FREDERICK COUNTY PLANNING COMMISSION
January 16th, 2013

BJ's Restaurant-FSK Mall

SP 74-01, AP #12931, FRO 12934

STAFF REPORT

Graphic #1

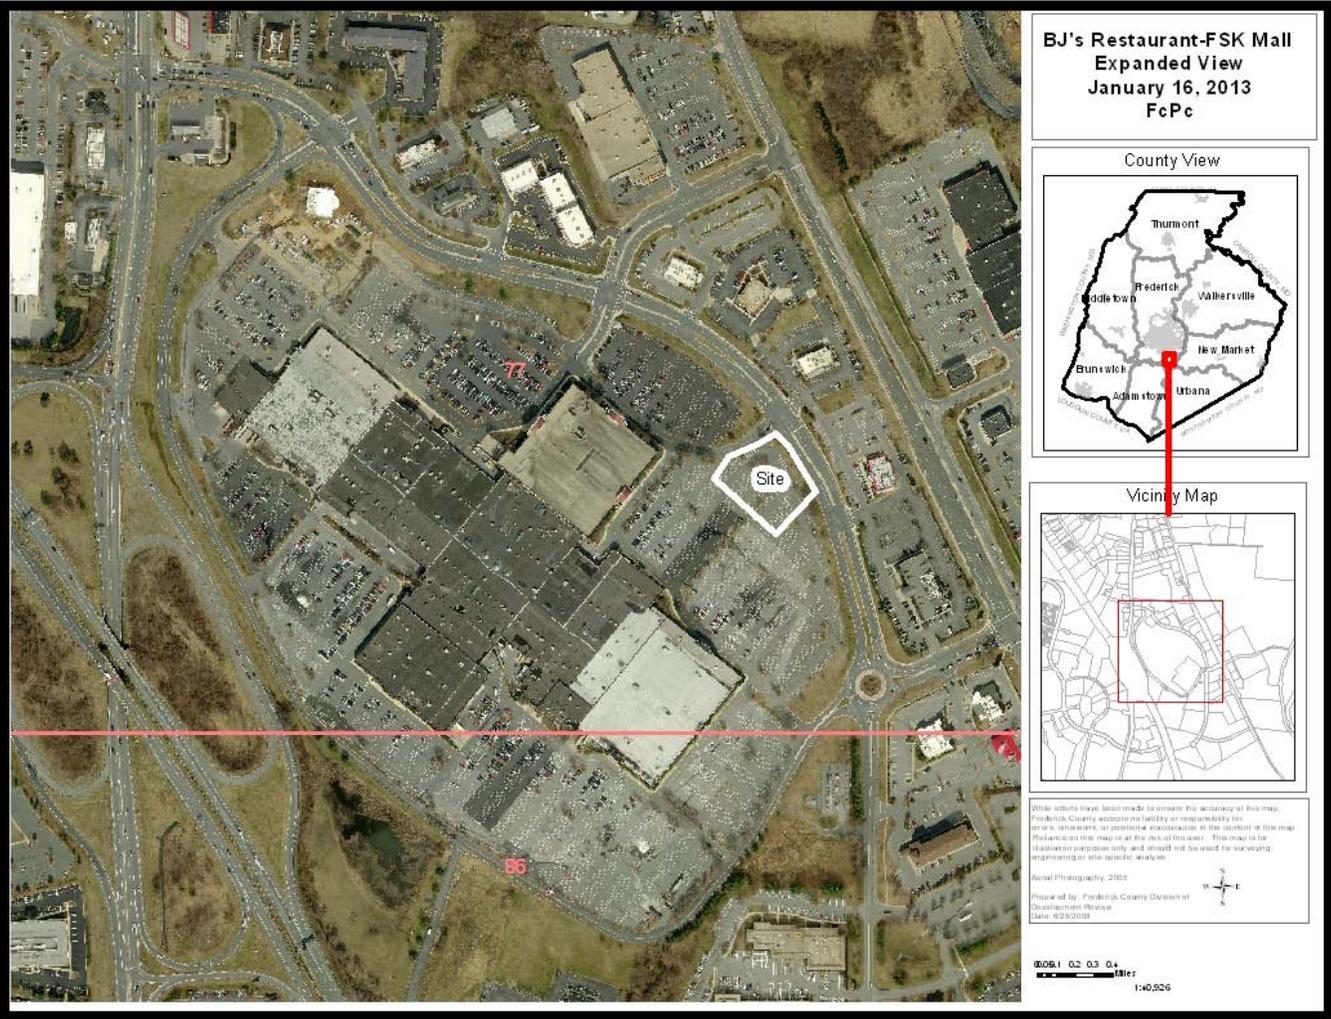
The Applicant is requesting site plan approval for a 10,642 square foot restaurant, with 6,489 square feet devoted to customer service. The Applicant is also proposing 130 parking spaces, including 5 handicapped accessible spaces (See Graphic #1). The proposed use is being reviewed as a "Restaurant" land use under the heading of *Commercial Business and Personal Services* per §1-19-5.310 Use Table in the Zoning Ordinance and is a principal permitted use in the General Commercial Zoning District subject to site development plan approval.

Graphic #3

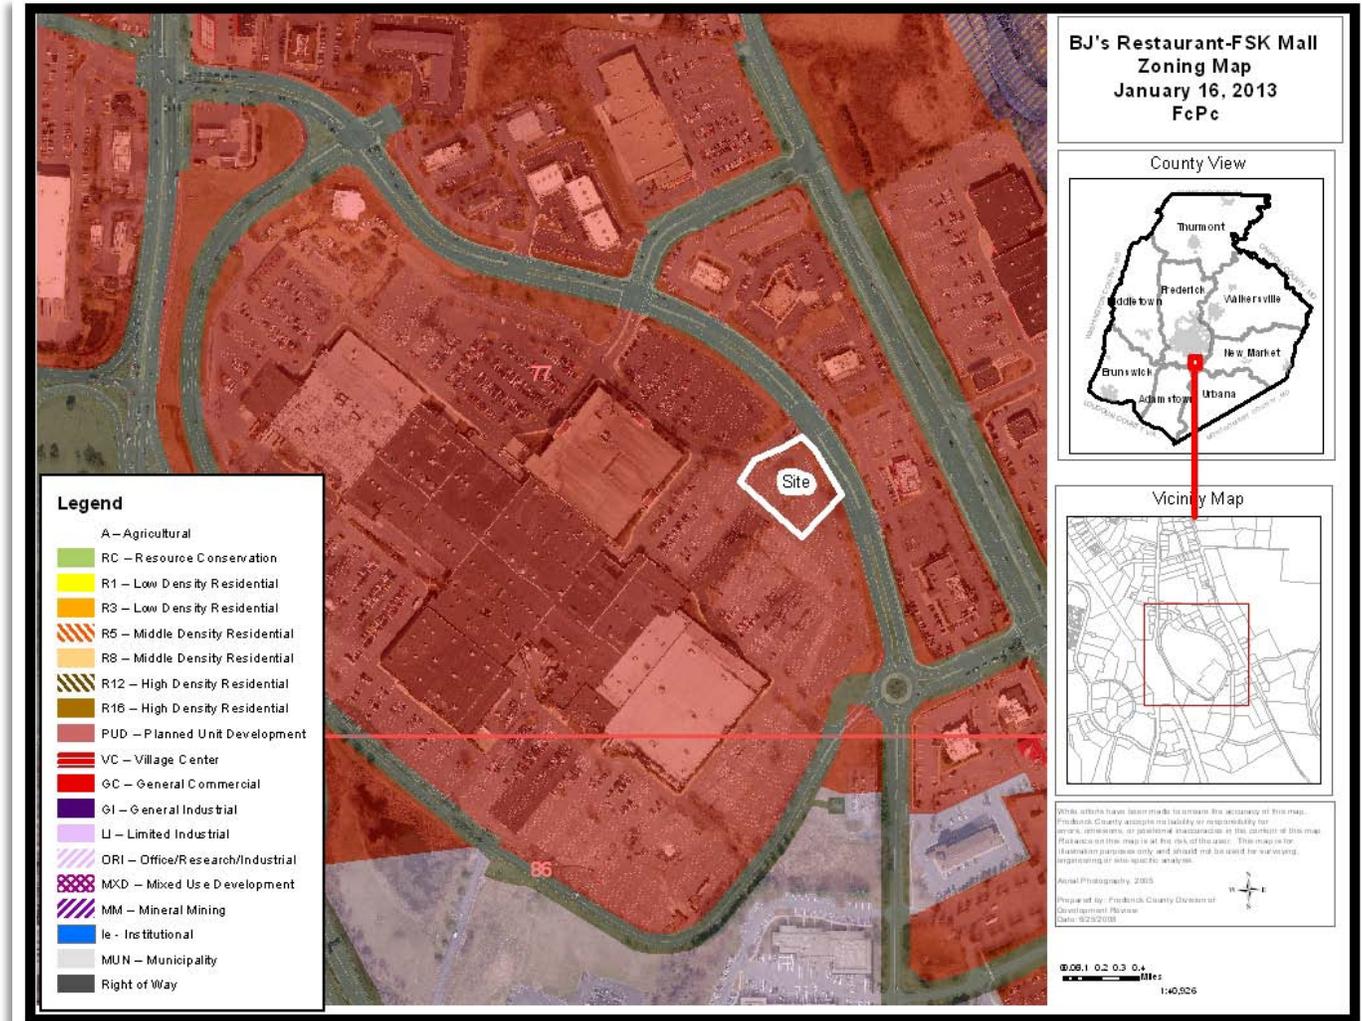
The site is currently zoned General Commercial (GC), and is developed as parking for FSK Mall (See Graphic #3). The property to the west of the site is developed with the FSK Mall, and 3,600 parking spaces.
